**METROPOLITAN COAL PROJECT
RESPONSES TO SUBMISSIONS
PART C**

**METROPOLITAN COAL PROJECT
RESPONSES TO
PLANNING ASSESSMENT COMMISSION QUERIES**

24 February 2009

PLANNING ASSESSMENT COMMISSION
METROPOLITAN COAL PROJECT INFORMATION REQUEST

Figure GW-4. Contours of total piezometric head [mAHD] along column 100 for “final” mining consisting of Longwalls 15-44 (pink in Layer 12), 1-14 (green in Layer 12) and neighbouring mines (yellow in Layer 12): [a] Standard-MODFLOW; [b] MODFLOW-SURFACT

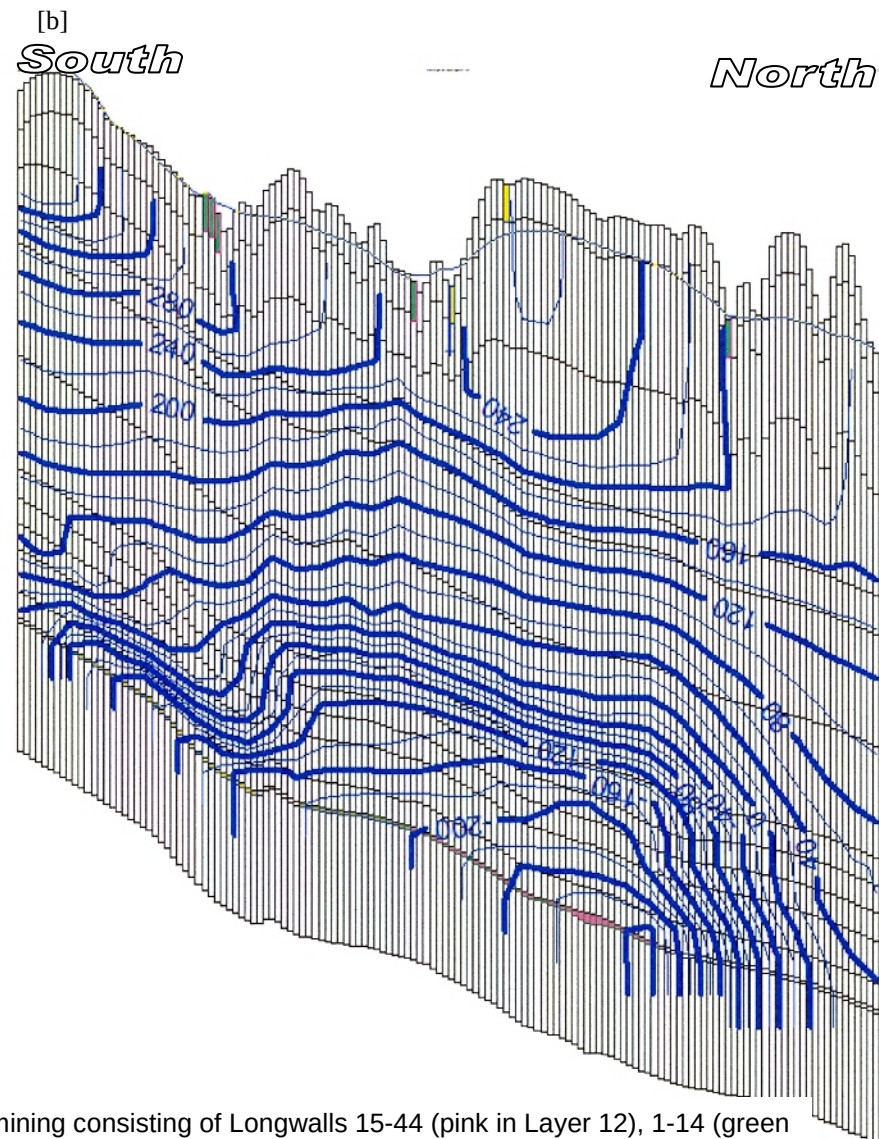
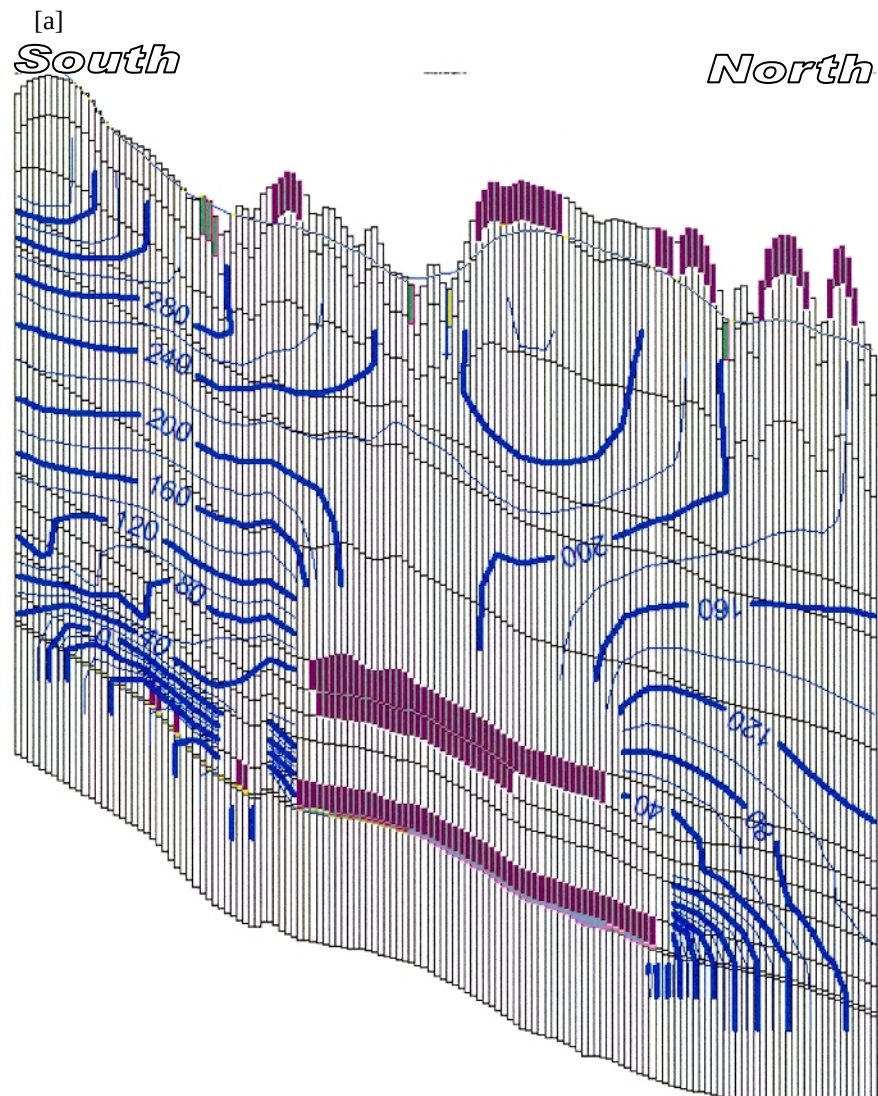
44.	Groundwater modelling in the EA utilised Modflow while modelling in a more recent report utilised the Surfact variant. It would be useful to see and compare a vertical section plot for each model which clearly shows contours of formation pore pressures - say column 100 in the model (steady state). This section needs to be generated in sufficient detail to indicate the freely draining zone above goaves for current and proposed longwalling.	Page 117

For the *final mining* scenario, the comparison of simulated groundwater level contour maps is presented in Figure GW-4. Layer 12 is colour coded to indicate mined cells - yellow for neighbouring mines; green for Longwalls 1-14; and pink for Longwalls 15-44 (in accordance with Figure GW-2). “Dry” cells are more extensive with Standard-MODFLOW [Figure 4(a)], rising up to Layer 7 (Stanwell Park Claystone). Figure GW-4(b) shows that MODFLOW-SURFACT is able to calculate consistent heads across the depressurized fractured zone above the longwall panels. The lateral extent of depressurization is greater (than for the recent mining case), but there is no apparent increase in the height of depressurization.
